NOTICE TO CONTRACTOR AND ALL SUB-CONTRACTORS **September 16, 2025**

Astra Bank, Dodge City-New Facility - JGR Proj #25-3515

ADDENDUM NO. 1

Project No.: (EC2025-13) 9/16/2025 2 OF 16

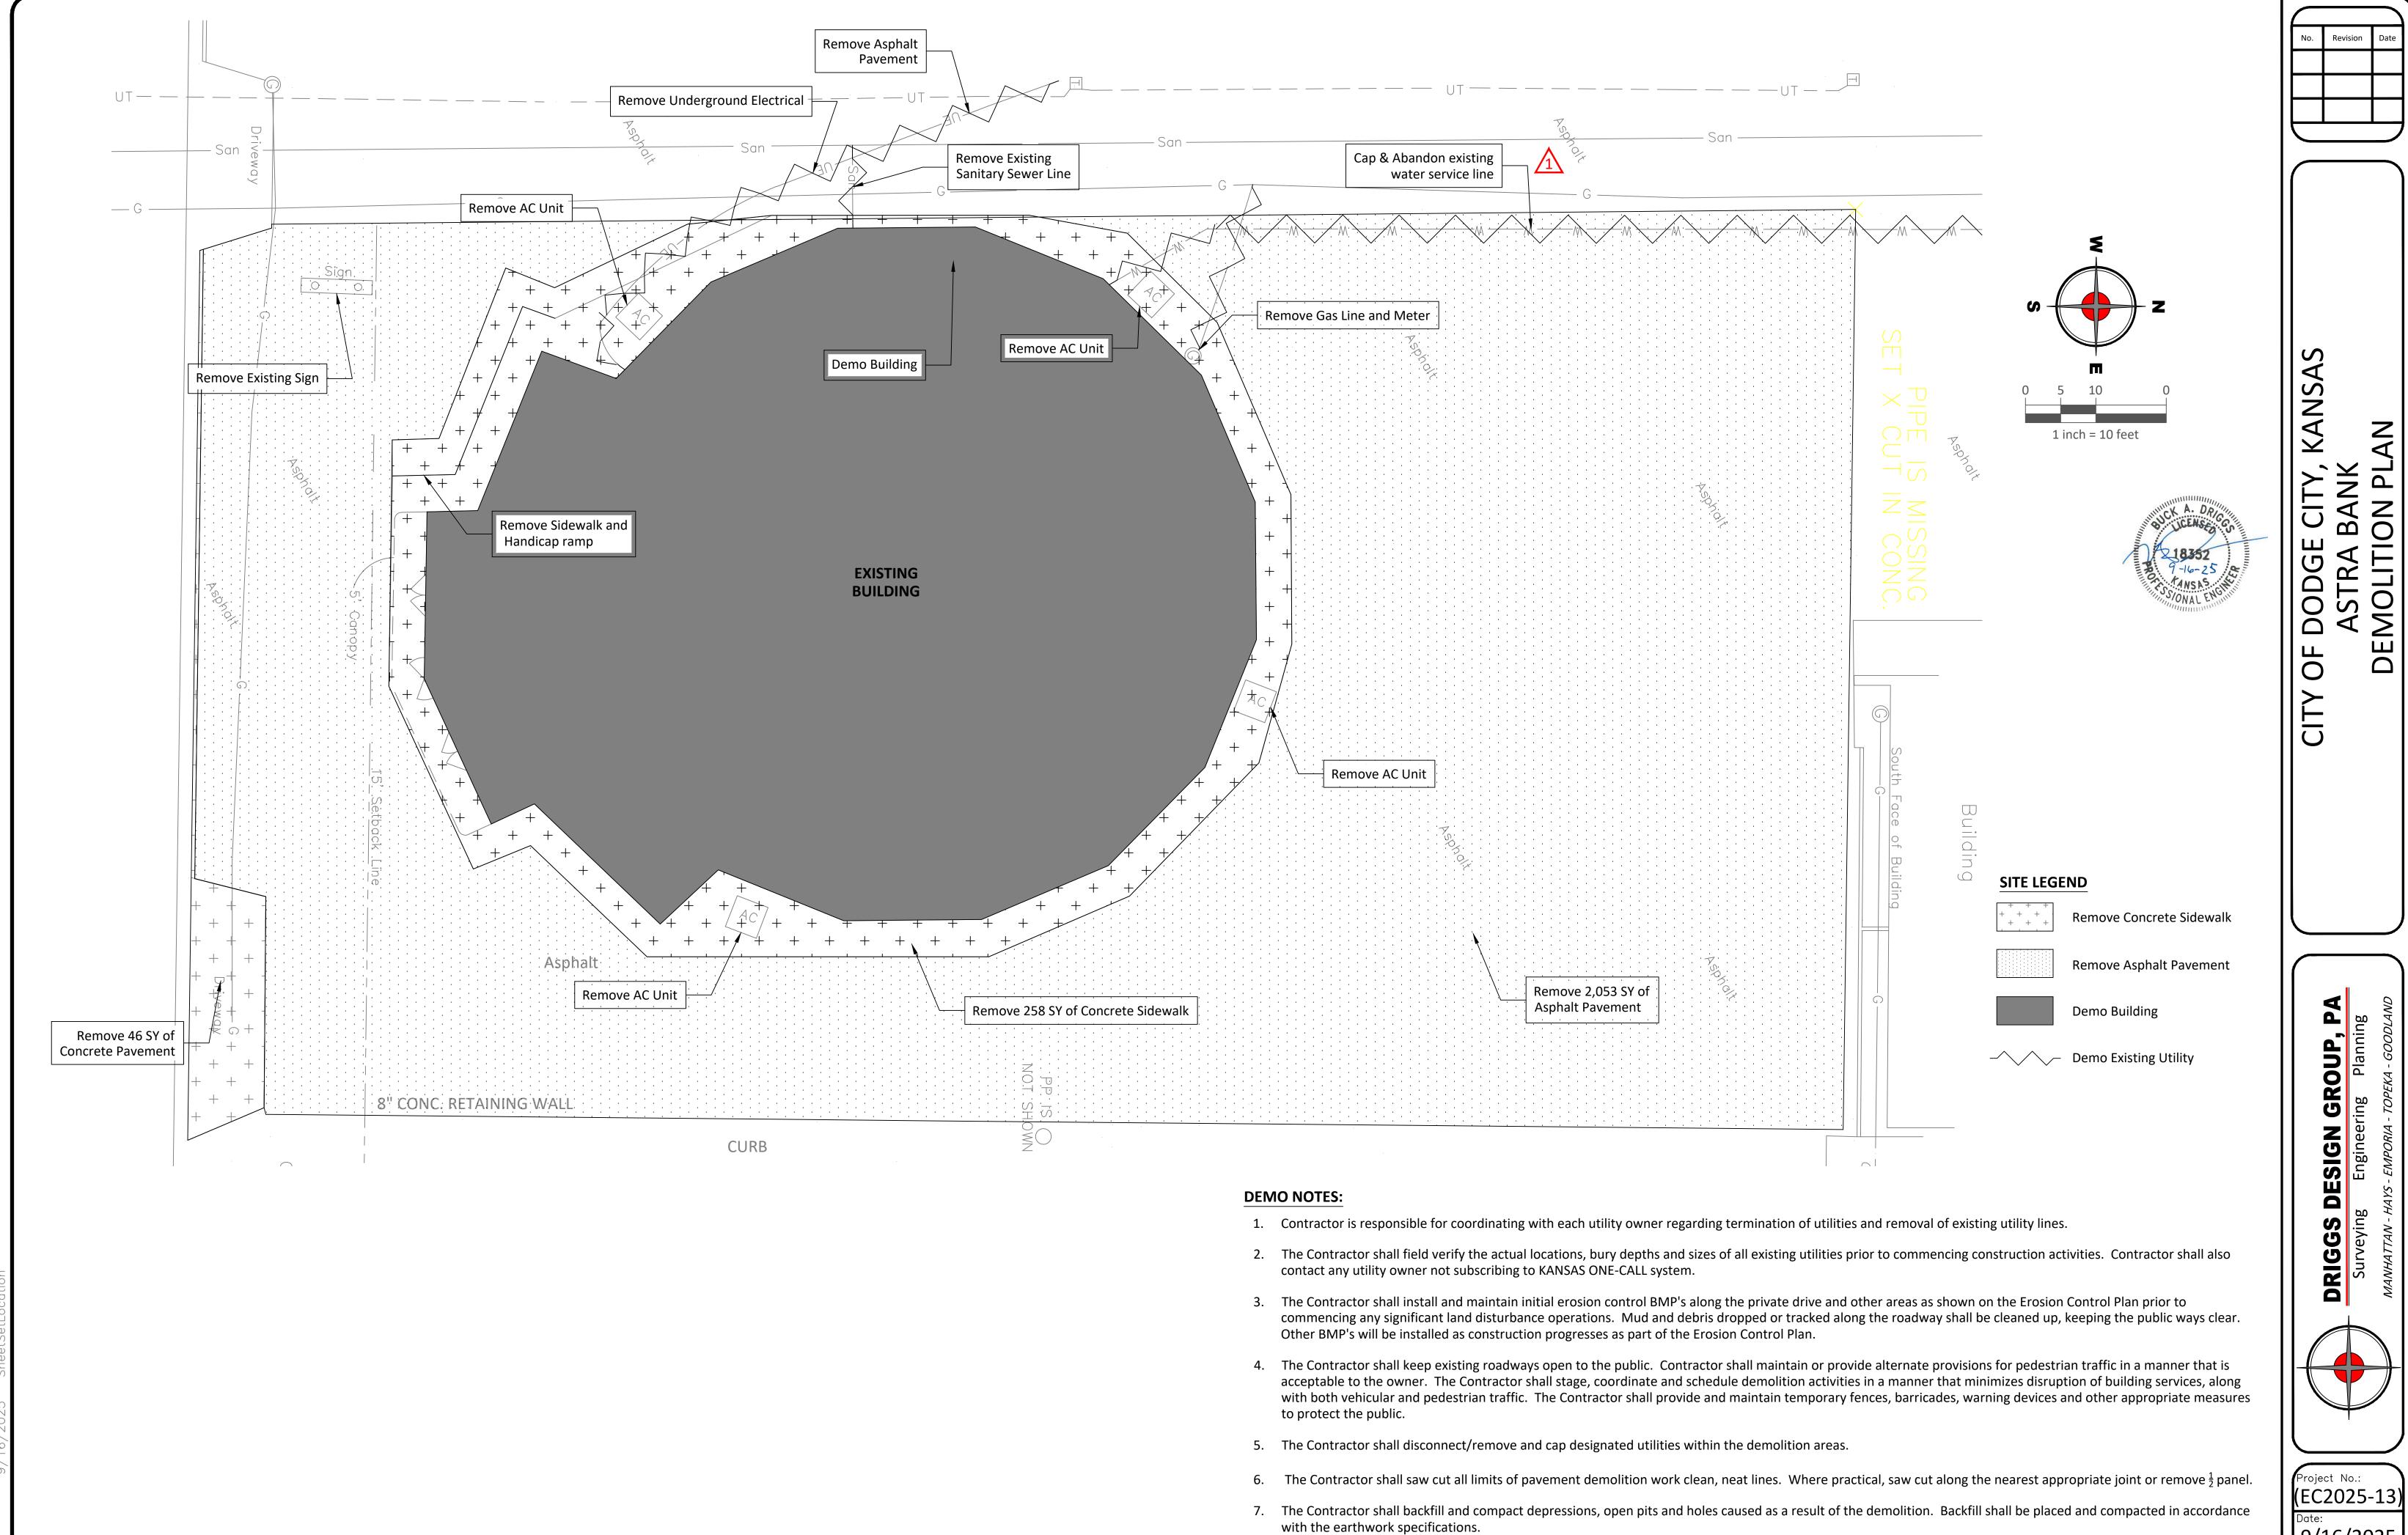
- Sheet 2 Revised to indicate new 2" water service and meter. Sheet 4 Revised to indicate water service changes.
- Sheet 5 Revised to indicate water service changes.
- Sheet 9 Revised to indicate extended area of new 2" water service line to the north per the request of Dodge City utility department.

E6.1

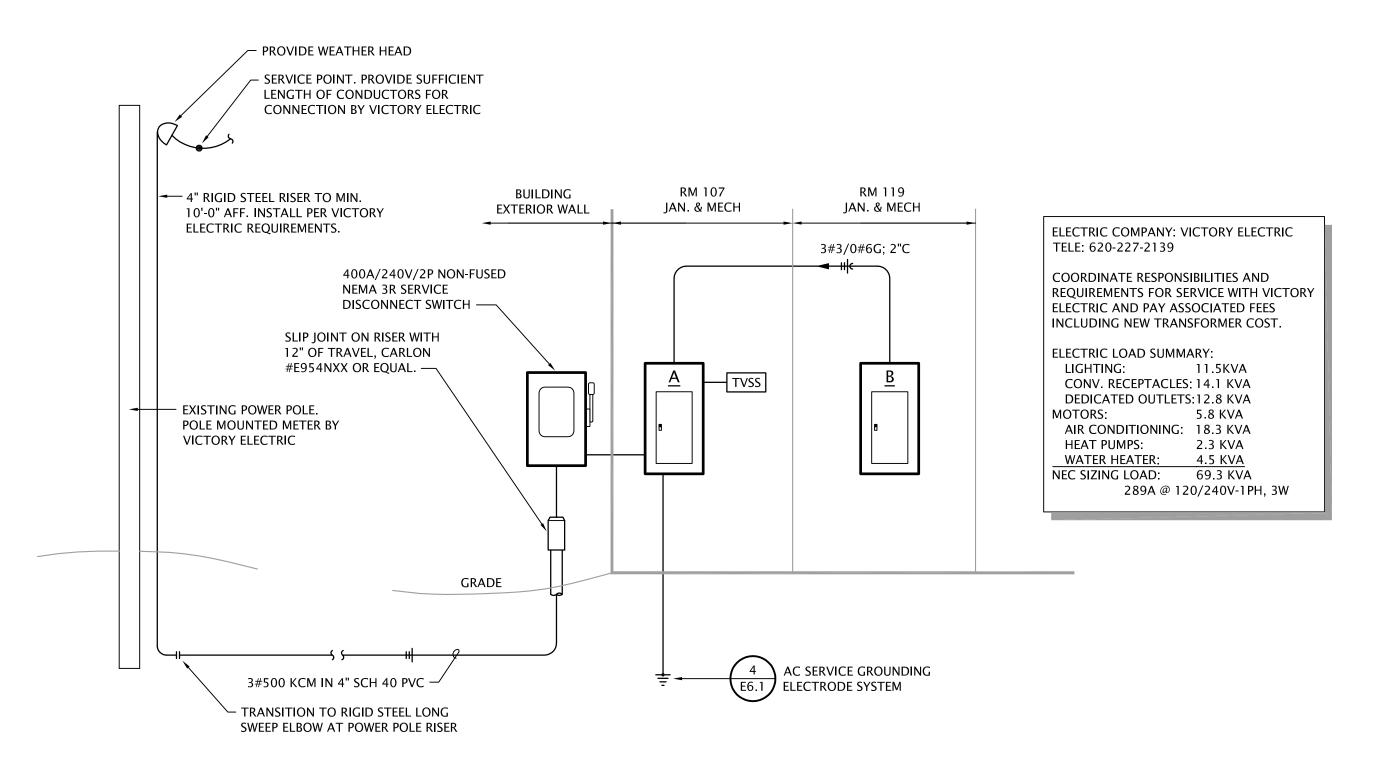
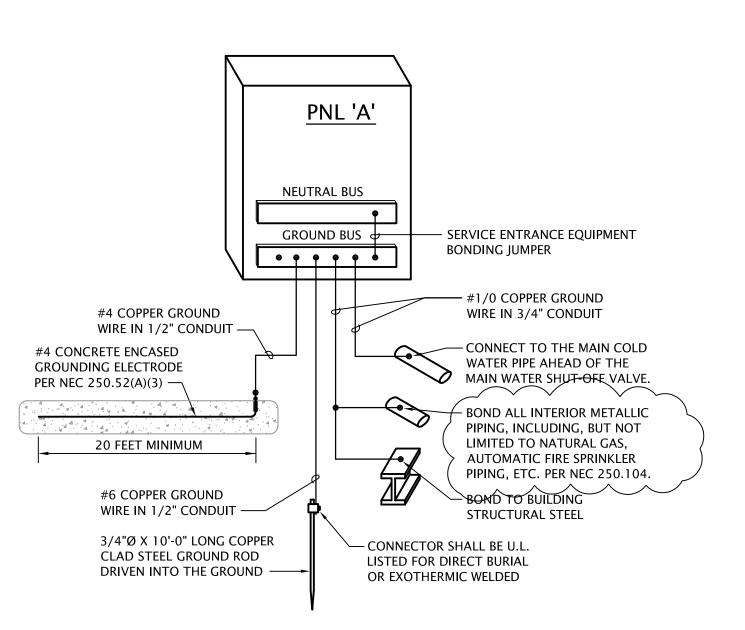
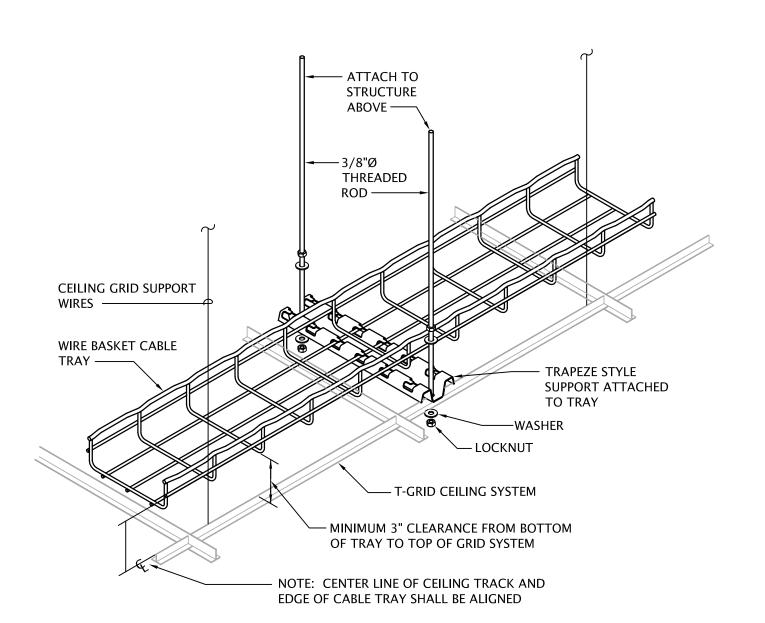
Sheet E6.1, Detail 2 – Sheet has been revised to indicate bonding on the gas line.
